NRL Report No.B-1218

Report of Test

Horns, Type A,
Submitted by Clark Cooper Company,
Philadelphia, Pa.

PLATE 2

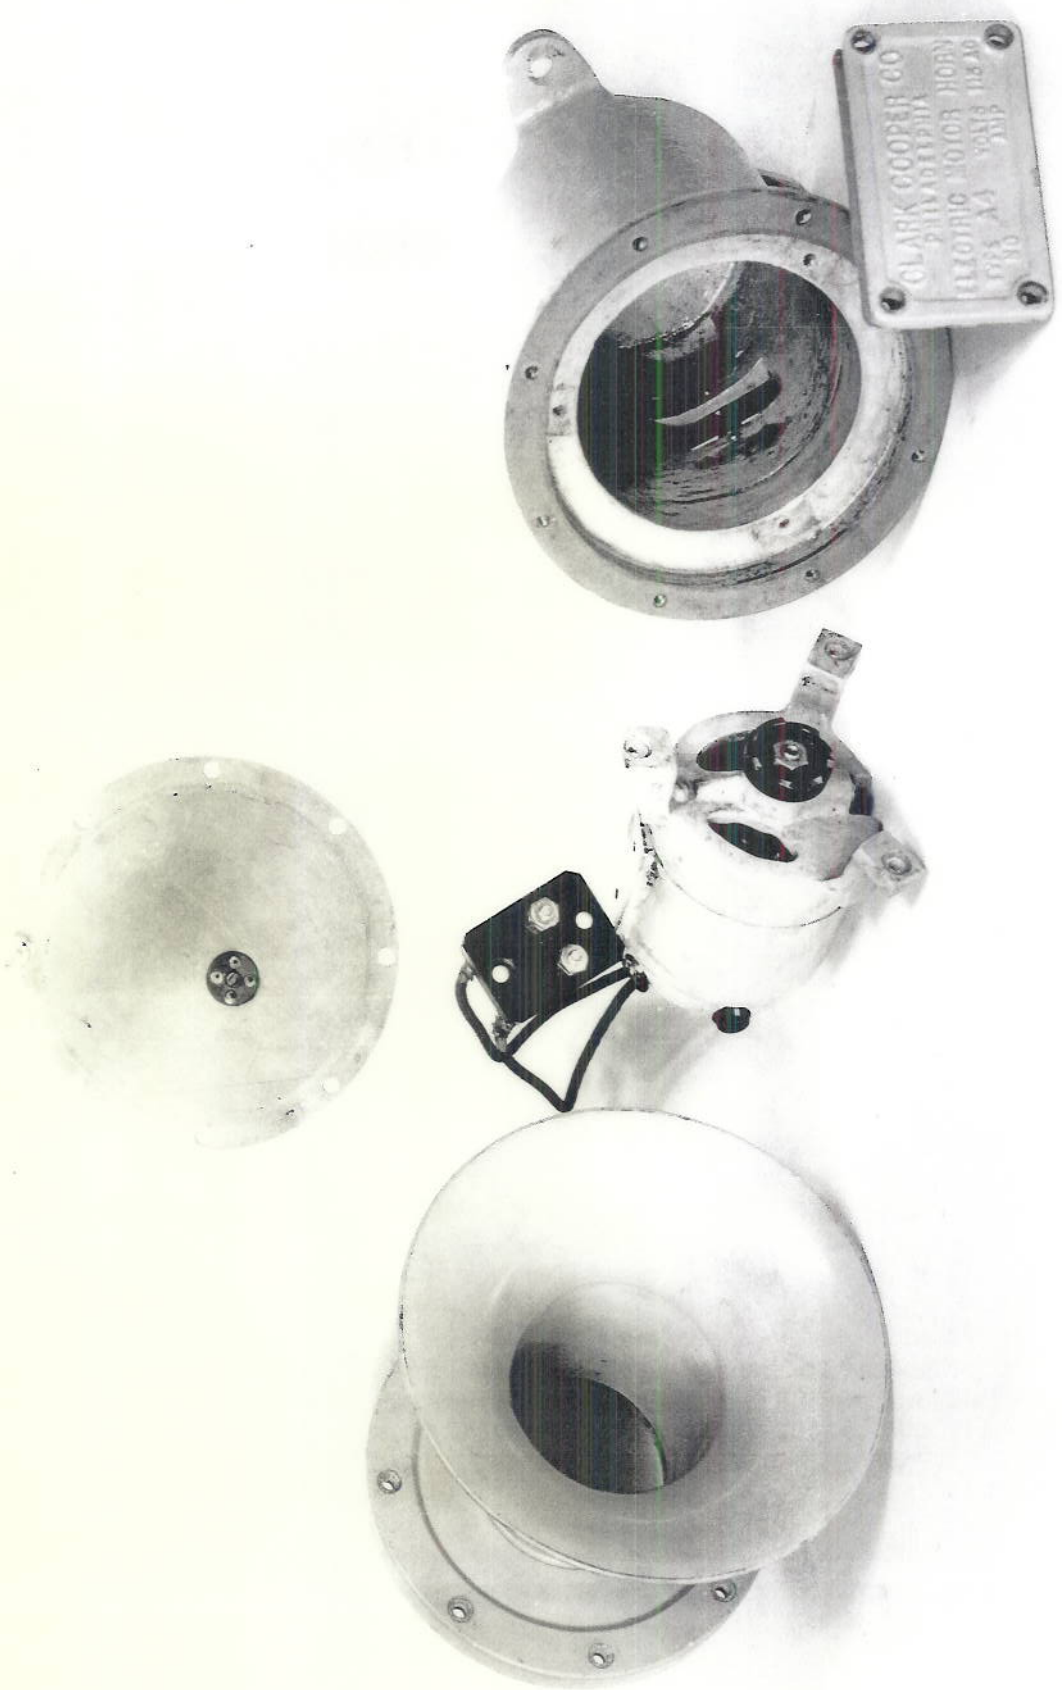
26. The holes for the three (3) brass screws, securing the motor, extend through the case. Small external bosses would provide more metal for the tapped hole and increase the watertight integrity of the horn.

27. The horn projector ring is provided with but one drain hole, approximately 1/16" diameter. To insure proper drainage, four equally spaced holes, at least 1/8" diameter, should be provided.

28. The gasket rubber is of a poor grade, adhering to the metal and tearing easily when removing the terminal box cover or projector ring.

29. The terminal block and terminal lugs furnished are not in accordance with specifications, D-6b and D-6m.

30. All securing screws should be oval, fillister head, as required by paragraph D-6o specifications.
